# UNITED STATES PATENT AND TRADEMARK OFFICE

APPLICATION NO.	FILING DATE	FIRST NAMED INVENTOR	ATTORNEY DOCKET NO.	CONFIRMATION NO.
10/522,044	01/19/2005	Peter Drott	PCT10483US	3988
23122	7590	08/22/2007	EXAMINER	
RATNERPRESTIA			LEE, GILBERT Y	
P O BOX 980			ART UNIT	
VALLEY FORGE, PA 19482-0980			PAPER NUMBER	
			3673	
			MAIL DATE	
			DELIVERY MODE	
			08/22/2007	
			PAPER

## Office Action Summary

## **DETAILED ACTION**

**FIG. 2**

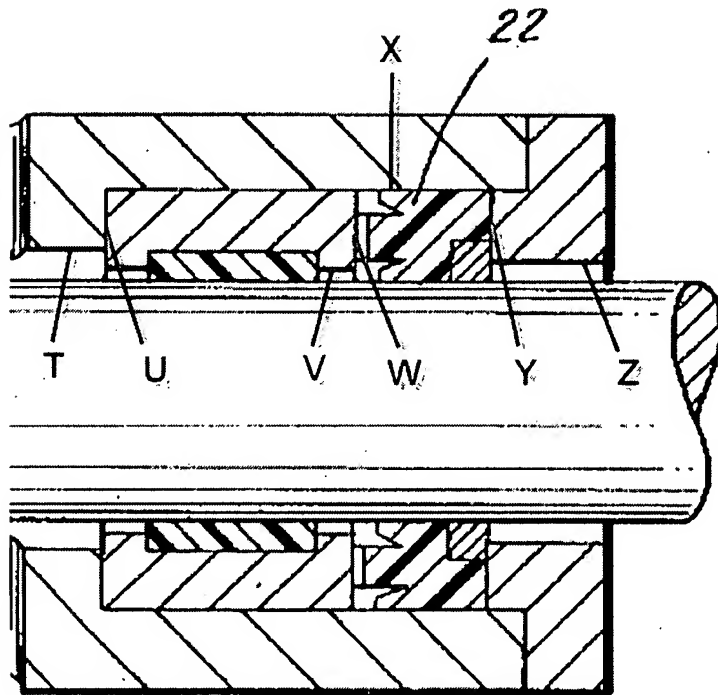
Regarding claim 15, the Zollner reference, as best understood, discloses a cylinder-and-piston unit (Col. 1, Lines 5-15) comprising a cylinder (e.g. including 5, D, and upper element 21 in contact with 22), a piston (6) and a sealing collar (22), the cylinder comprising a bore (e.g. bore of cylinder accommodating piston 6), and the cylinder having a wall surface (e.g. inner most surface of cylinder) along the bore, the wall surface comprising a first sidewall (V) extending parallel to a longitudinal axis of the bore (Fig. 2), a second sidewall (W) contiguous with the first sidewall and extending

generally perpendicularly to the first sidewall (Fig. 2), a third sidewall (X) contiguous with the second sidewall and extending generally parallel to the first sidewall (Fig. 2), a fourth sidewall (Y) contiguous with the third sidewall and extending generally parallel to the second sidewall (Fig. 2), and a fifth sidewall (Z) contiguous with the fourth sidewall and extending generally parallel to the first sidewall along the bore (Fig. 2), the second, third and fourth sidewalls being parts of one unitary body, forming a groove (e.g. groove formed by walls W, X and Y) that is recessed in the wall surface (Fig. 2), the sealing collar being positioned in the groove (Fig. 2) and comprising an outside sealing lip (B) and an inside sealing lip (A), the outside and inside sealing lips each having a free end (i.e. the ends facing downwards in Fig. 2), the sealing collar further including a circumferential extension (C) that extends in parallel to the sealing lips (Fig. 2), being arranged radially between the outside sealing lip and the inside sealing lip and projects axially beyond the free ends of the outside and inside sealing lips (Fig. 2), the circumferential extension being configured to contact the second sidewall in the groove (Fig. 2) and maintain the free ends of the outside and inside sealing lips out of contact with the second sidewall (Fig. 2).

Regarding claim 16, the Zollner reference, as best understood, discloses a cylinder-and-piston unit (Col. 1, Lines 5-15) comprising a cylinder (e.g. including 5, D, and upper element 21 in contact with 22), a piston (6) and a sealing collar (22), the cylinder comprising a bore (e.g. bore of cylinder accommodating piston 6), and the cylinder having a wall surface (e.g. inner most surface of cylinder) along the bore, the wall surface comprising a first sidewall (V) extending parallel to a longitudinal axis of the

bore (Fig. 2), a second sidewall (W) contiguous with the first sidewall and extending generally perpendicularly to the first sidewall (Fig. 2), a third sidewall (X) contiguous with the second sidewall and extending generally parallel to the first sidewall (Fig. 2), a fourth sidewall (Y) contiguous with the third sidewall and extending generally parallel to the second sidewall (Fig. 2), and a fifth sidewall (Z) contiguous with the fourth sidewall and extending generally parallel to the first sidewall along the bore (Fig. 2), the second, third and fourth sidewalls being parts of one unitary body and forming a groove (e.g. groove formed by walls W, X and Z) that is recessed in the wall surface (Fig. 2), the sealing collar being positioned in the groove (Fig. 2) and comprising a first sealing lip (A) and a second sealing lip (B), the first sealing lip being acted upon dynamically and making contact with the piston (Fig. 2) and the second sealing lip thereof being acted upon statically while resting on a bottom of the groove (Fig. 2), the first and second sealing lips each having a free end (i.e. the ends facing downwards in Fig. 2), the sealing collar further including a circumferential extension (C) that extends between the first and second sealing lips (Fig. 2), and projects from the first and second sealing lips in an axial direction beyond the free ends of the first and second sealing lips (Fig. 2), the sealing collar having a rear surface (e.g. surface of element 22 in contact with element D) opposite the free ends of the first and second sealing lips, wherein the sealing collar has a maximum radial width at the free end of the second sealing lip and a minimum radial width at the rear surface (Fig. 2). Note that the radial width at the rear surface will always be smaller than the maximum width because of supporting ring 1.

Regarding claim 17, the Zollner reference discloses the axial width of the groove being larger than the axial width of the sealing collar (Fig. 2). Note that the axial width of the groove of the Zollner reference is larger than the axial width of the sealing collar at different cross sections.

Regarding claim 18, the Zollner reference discloses the second sealing lip (B). Note that the second lip of the Zollner reference is capable of being passed over by pressure fluid flow and hence provide the effect of a valve, because the structure as claimed in claim 16 is the same as the structure of the Zollner reference.

Regarding claim 19, the Zollner reference discloses the strength of the extension as a difference between its inside and outside diameters has at least the same rate as the strength of each of the sealing lips. Note that the seal of the Zollner reference is made of one material and since the extension has a thicker diameter, it will have a strength that is equal, if not greater, than the strength of the lips.

Regarding claim 20, the Zollner reference discloses the extension being provided with radial apertures (F). Note that the apertures are capable of allowing pressure fluid to pass through in a radial direction.

Regarding claim 22, the Zollner reference discloses the apertures being open in an axial direction towards the free end of the extension (Fig. 2).

Regarding claim 23, the Zollner reference discloses the extension being integrally connected to the sealing collar and being made of the same material (Fig. 2).

Regarding claim 24, the Zollner reference discloses a cylinder-and-piston unit (Col. 1, Lines 5-15) comprising a cylinder (e.g. including 5, D, and upper element 21 in

contact with 22), a piston (6) and a sealing collar (22), the cylinder comprising a bore (e.g. bore of cylinder accommodating piston 6), and the cylinder having a wall surface (e.g. inner most surface of cylinder) along the bore, the wall surface comprising a first sidewall (V) extending parallel to a longitudinal axis of the bore (Fig. 2), a second sidewall (W) contiguous with the first sidewall and extending generally perpendicularly to the first sidewall (Fig. 2), a third sidewall (X) contiguous with the second sidewall and extending generally parallel to the first sidewall (Fig. 2), a fourth sidewall (Y) contiguous with the third sidewall and extending generally parallel to the second sidewall (Fig. 2), and a fifth sidewall (Z) contiguous with the fourth sidewall and extending generally parallel to the first sidewall along the bore (Fig. 2), the second, third and fourth sidewalls being parts of one unitary body and bordering a groove that is recessed in the wall surface (Fig. 2), the sealing collar being positioned in the groove and comprising an outside sealing lip (B) and an inside sealing lip (A), the outside and inside sealing lips each having a free end (i.e. the ends facing downwards in Fig. 2), the sealing collar further including a circumferential extension (C) that extends in parallel to the sealing lips (Fig. 2), is arranged radially between the outside sealing lip and the inside sealing lip and has a free end that projects axially beyond the free ends of the outside and inside sealing lips (Fig. 2), the circumferential extension engaging the second sidewall of the groove (Fig. 2) and maintaining the free ends of the outside and inside sealing lips out of contact with the second sidewall (Fig. 2).

Regarding claim 25, the Zollner reference discloses the free end of the circumferential extension being provided with radial apertures (F). Note that the apertures are **capable of** allowing pressure fluid to pass through in a radial direction.

Regarding claim 26, the Zollner reference discloses the sealing collar having a rear surface (e.g. surface of element 22 in contact with element 1 that is parallel to the surface of element C in contact with element 21) opposite the free ends of the outside and inside sealing lips, wherein the sealing collar has a maximum outside diameter at the free end of the outside sealing lip and a minimum outside diameter at the rear surface (Fig. 2). Note the minimum outside diameter is the same width as the supporting ring 1 and will always be smaller than the maximum diameter at the outside seal.
